Naco Ground Storage Tank Rehabilitation Project
SAWS Solicitation No. B-19-015
Job No. 17-0113

ADDENDUM 3
December 13, 2019

Attachment: Control Panel As-Builts

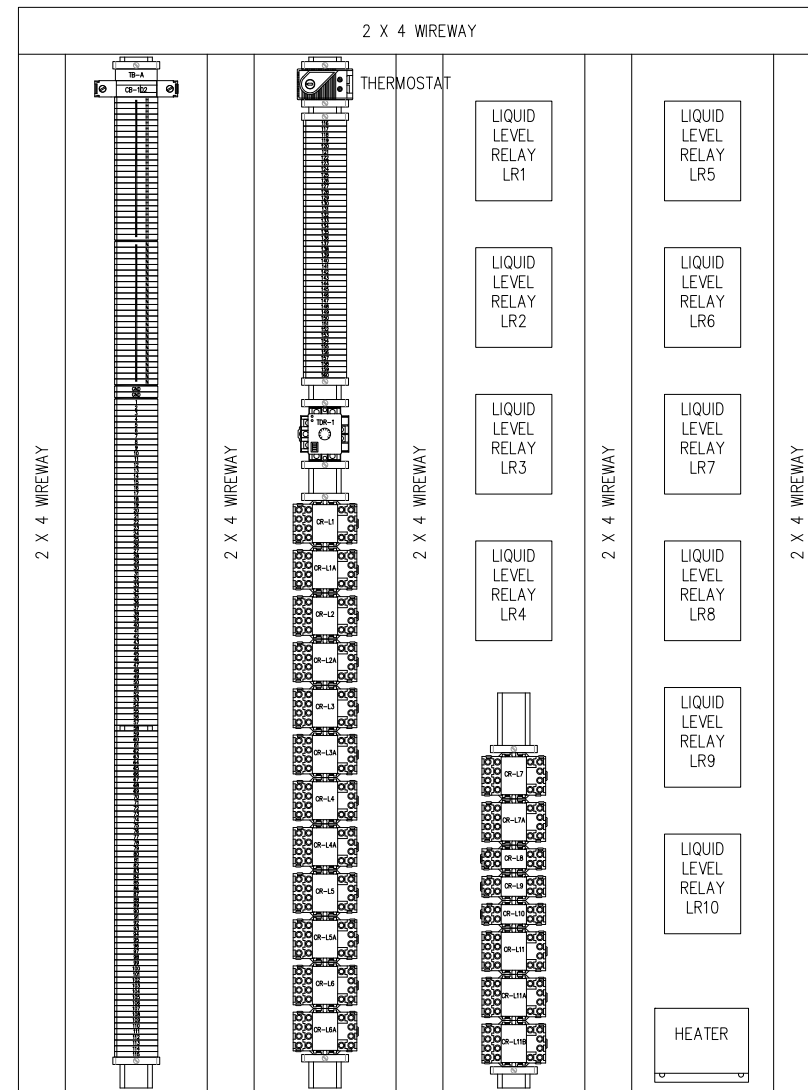
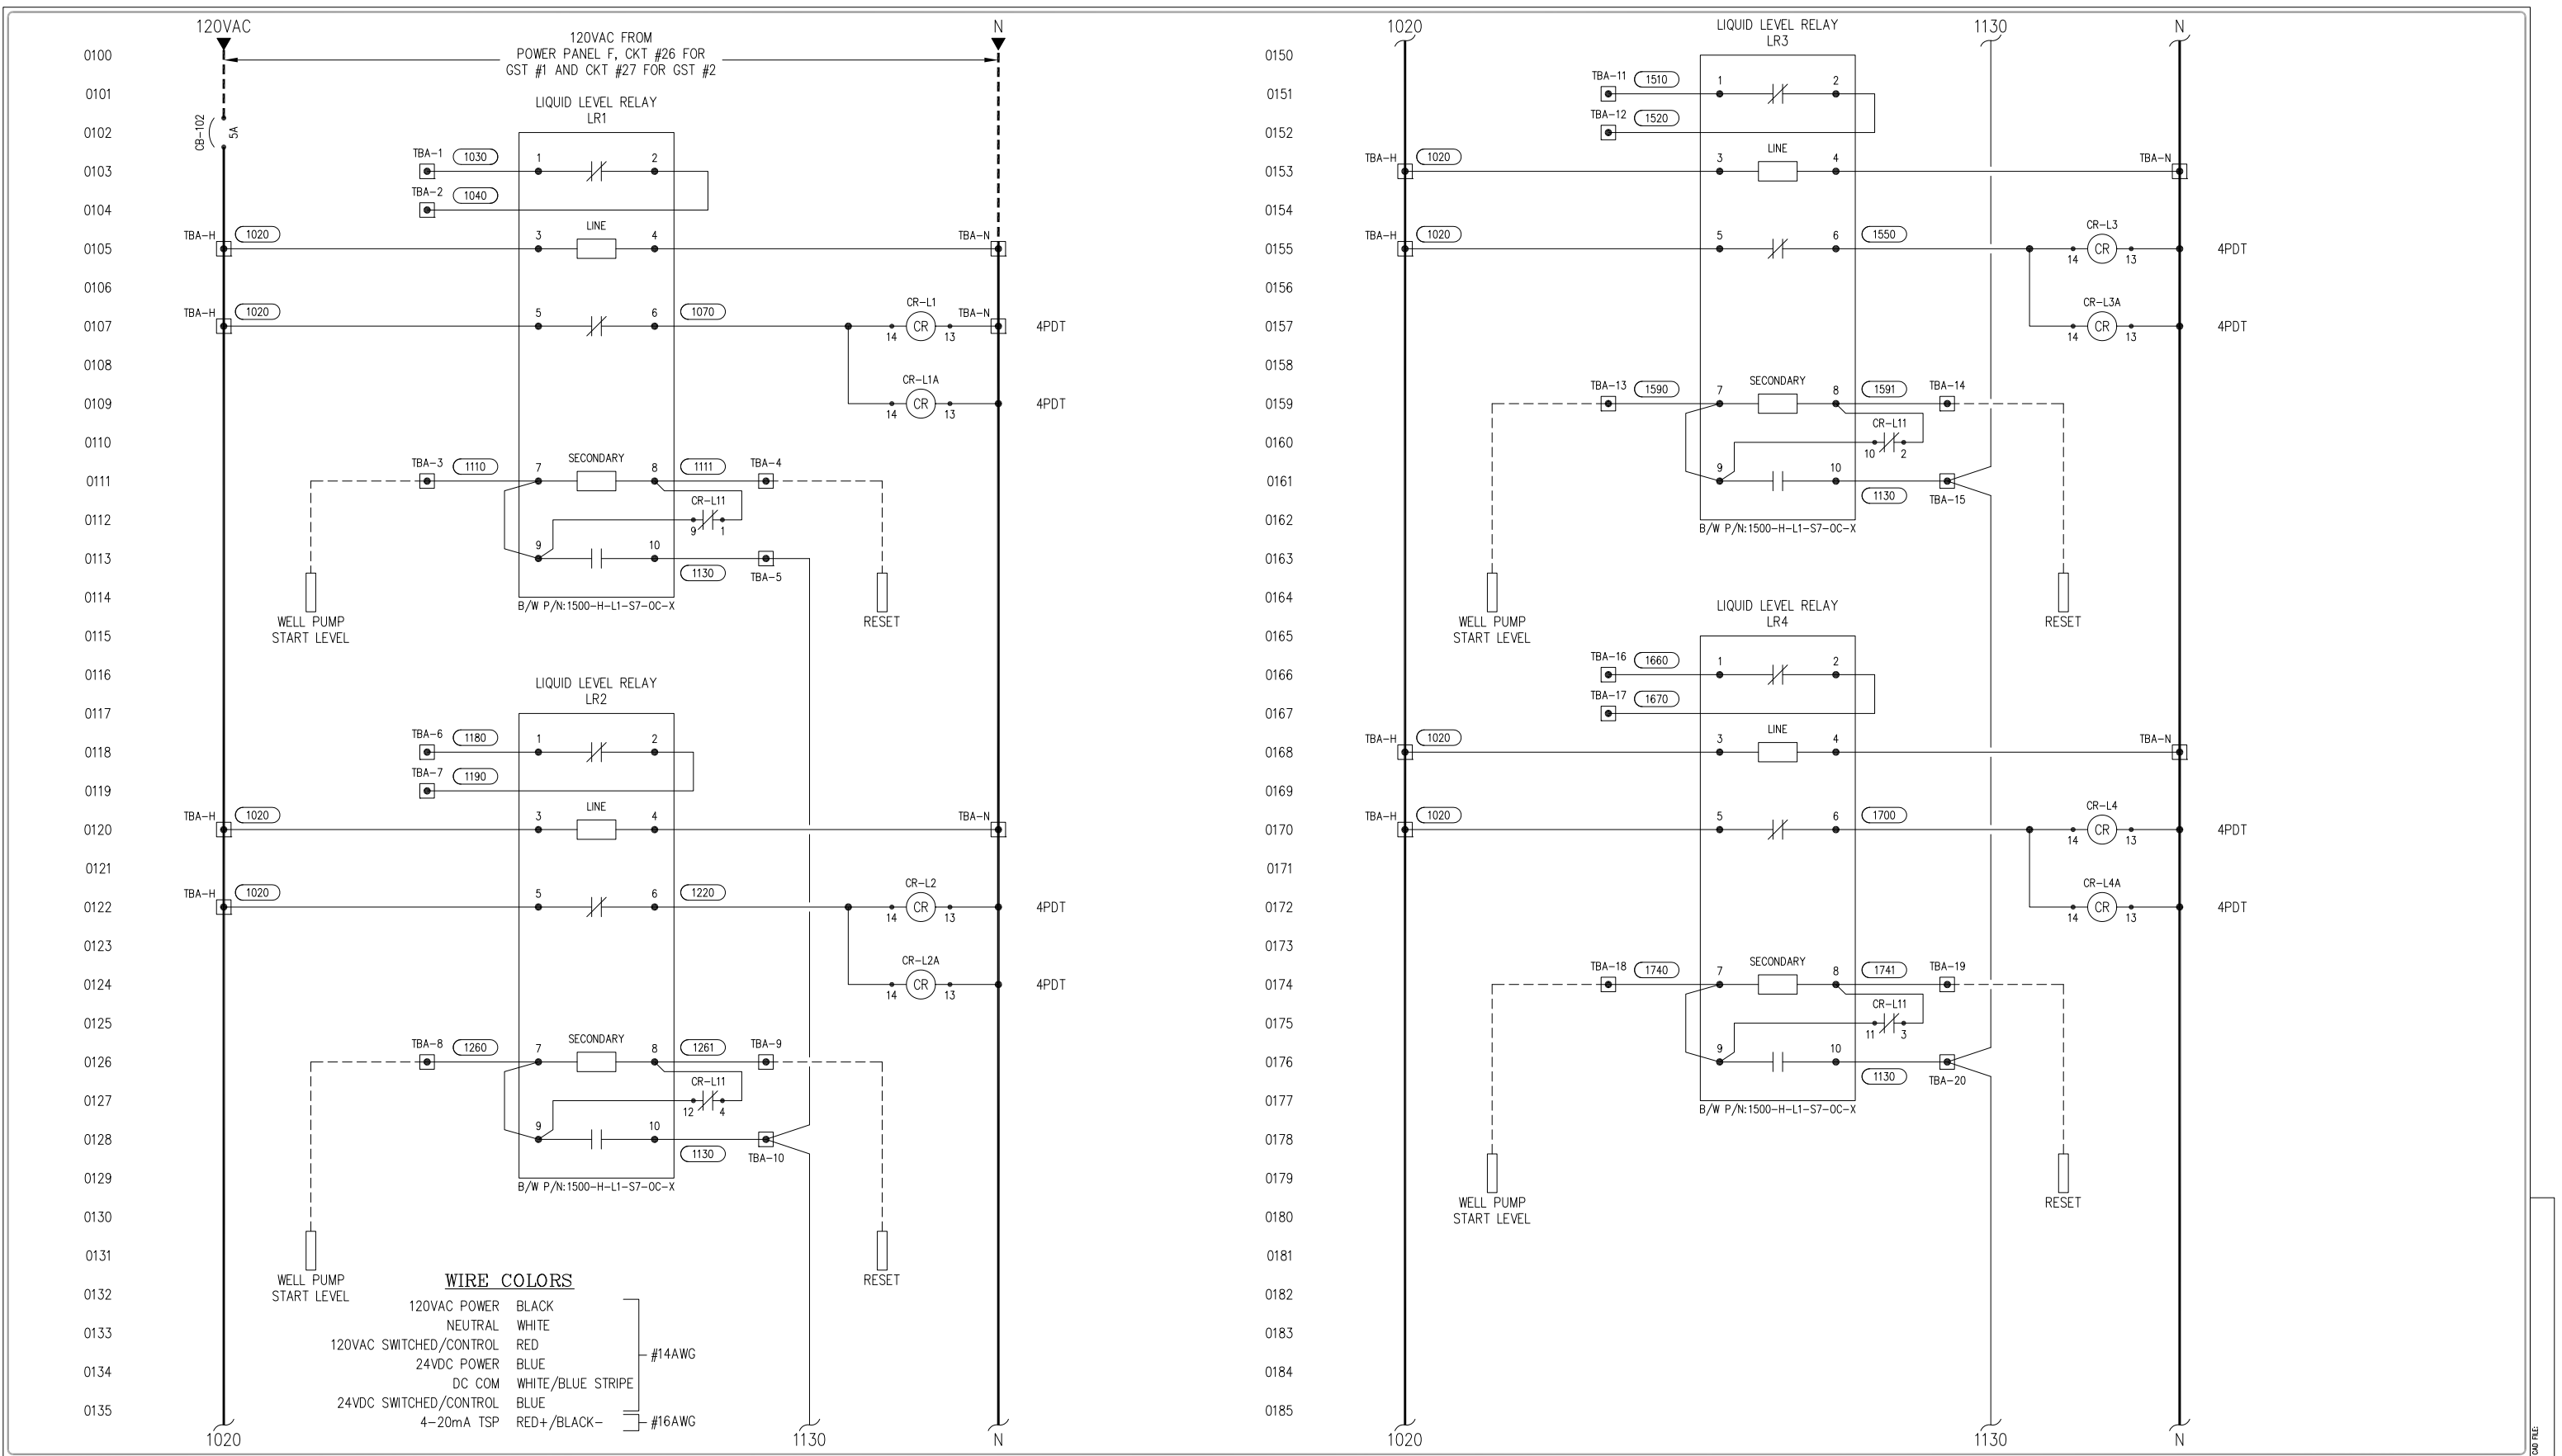
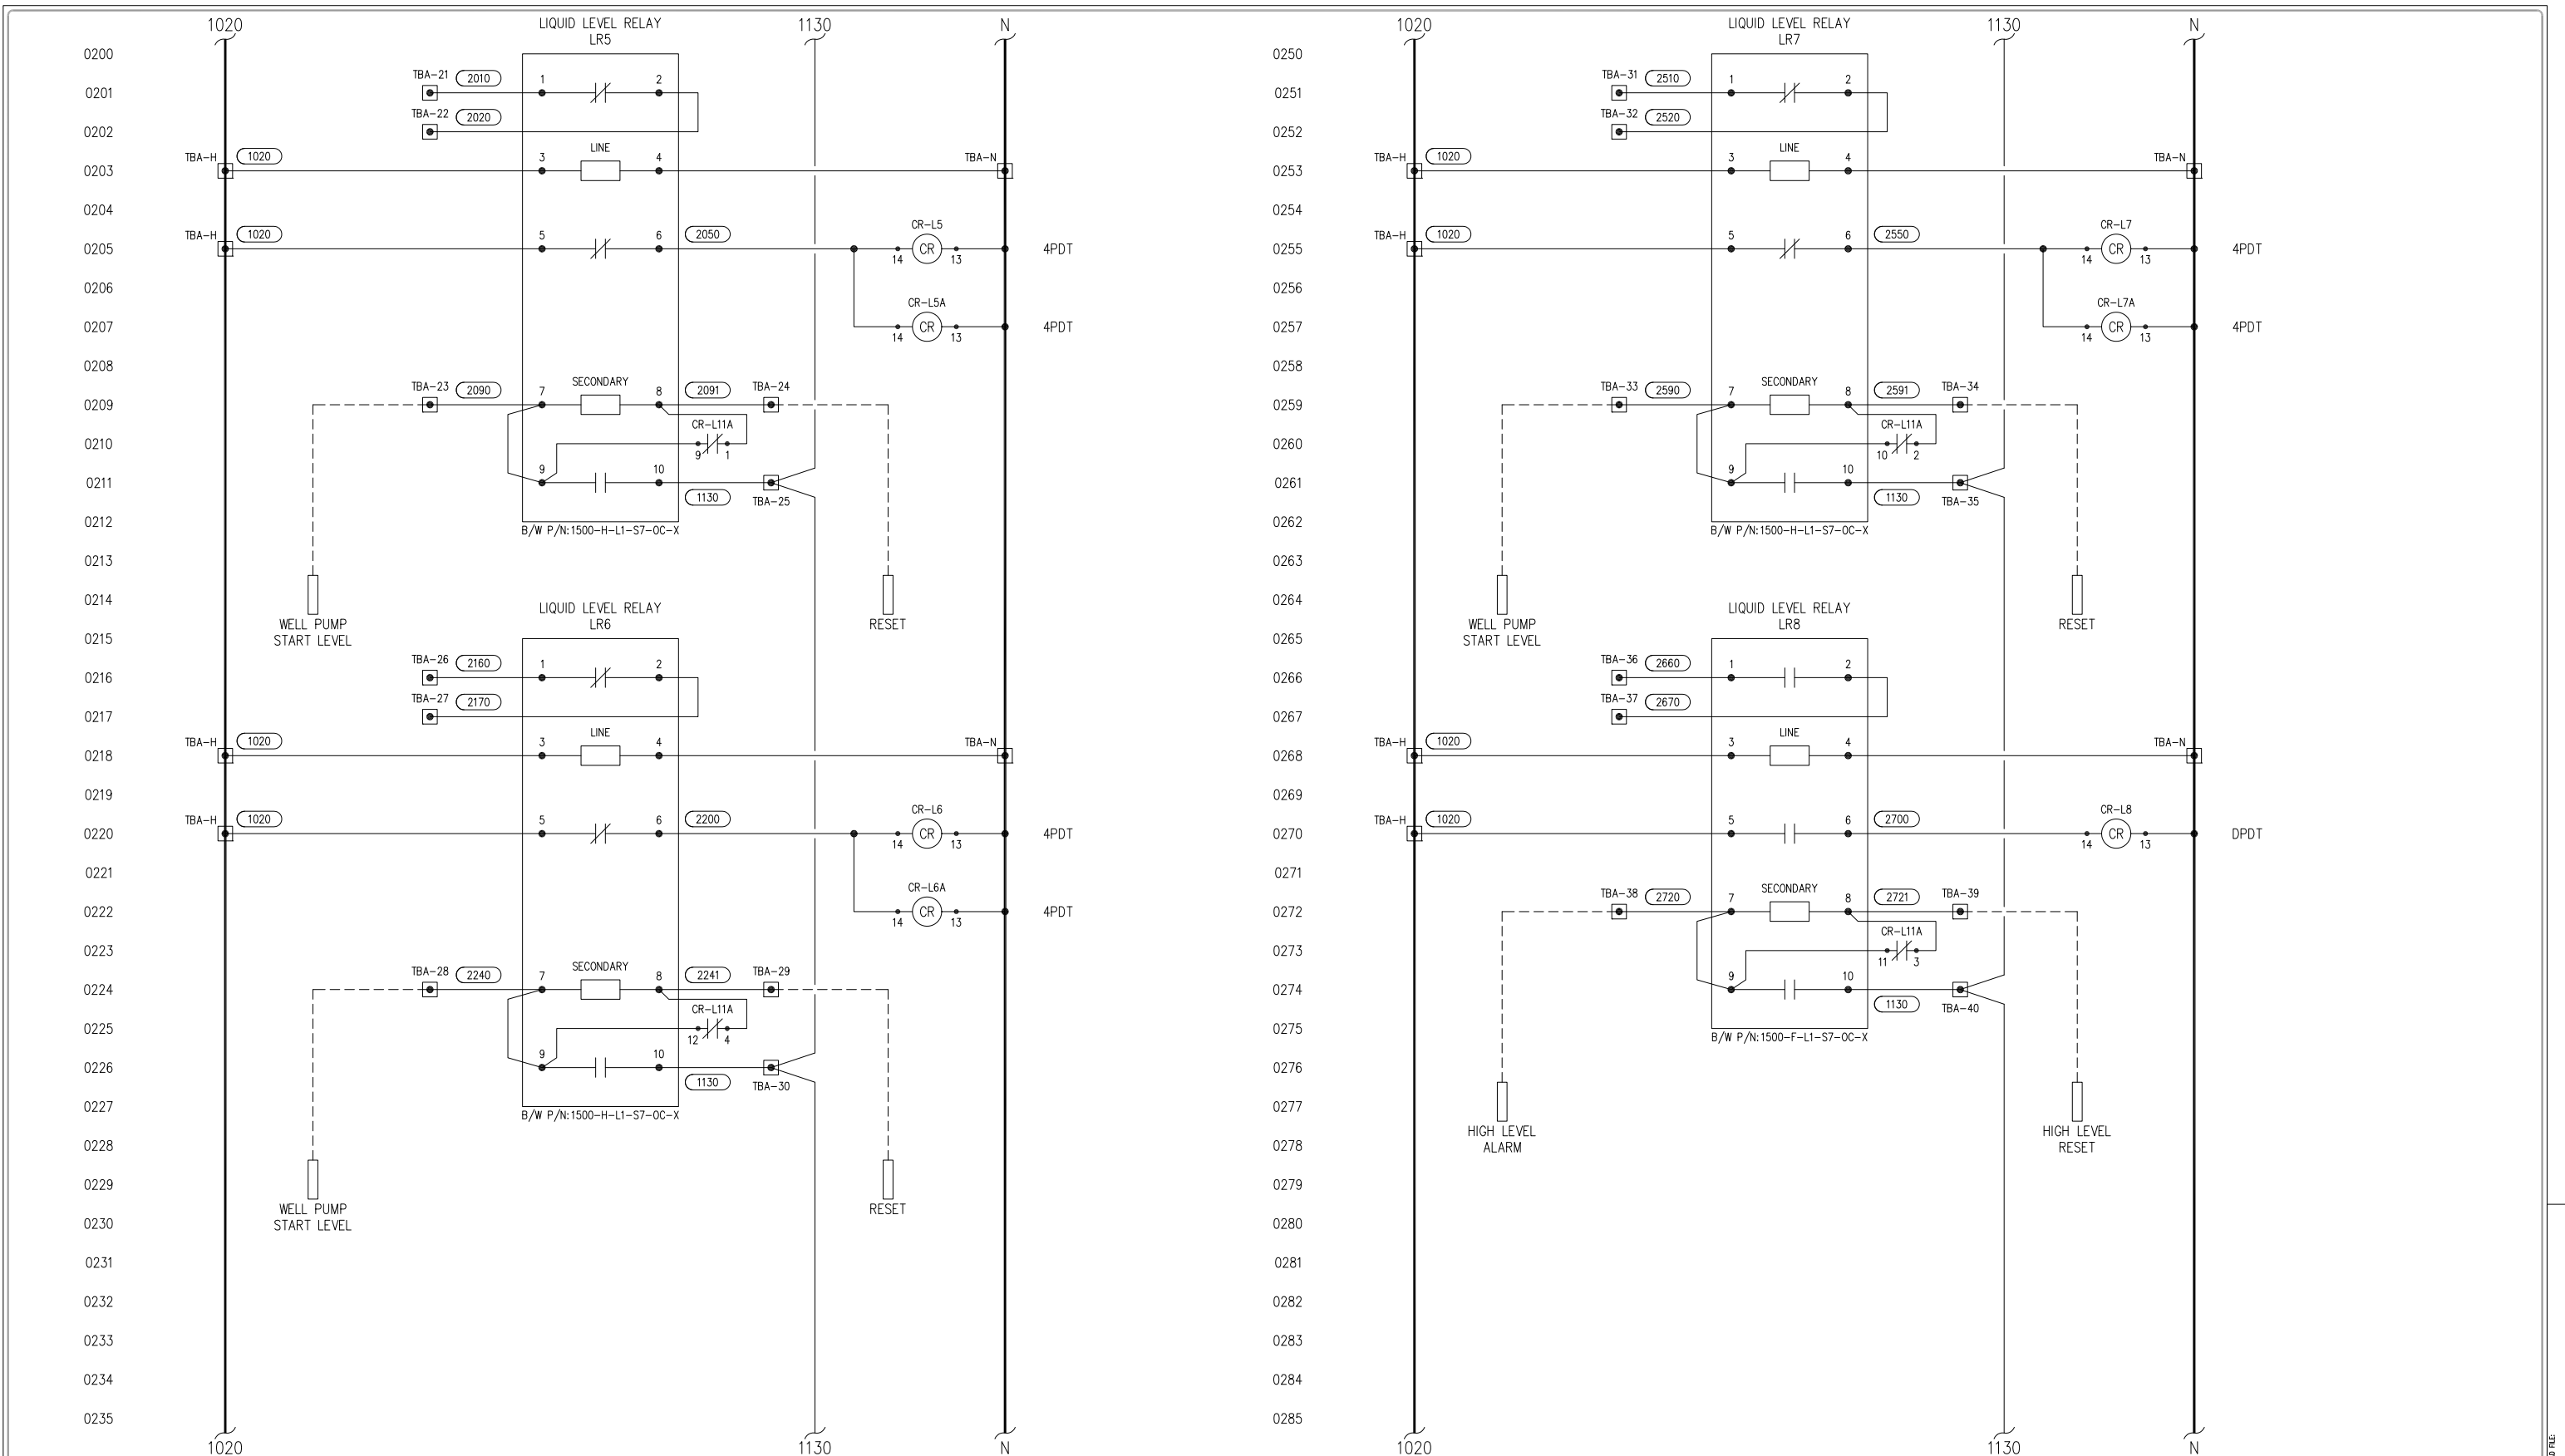
1. **Question:** Sheet E4 Keyed Note 3 states “THE NEW ELECTRODE PROBES TO BE CONNECTED TO EXISTING RELAYS IN LEVEL CONTROL PANEL. CONTRACTOR SHALL DOCUMENT ALL EXISTING CONNECTIONS AND RE-CONNECT NEW PROBES TO THE SAME TERMINALS.” However, during the site visit, we did not see any probe cables being routed to the level control panel. Please advise.?

Response: The previous contractor had already removed the probes and cable. Attached are the record drawings of this panel which are included in Addendum 3.
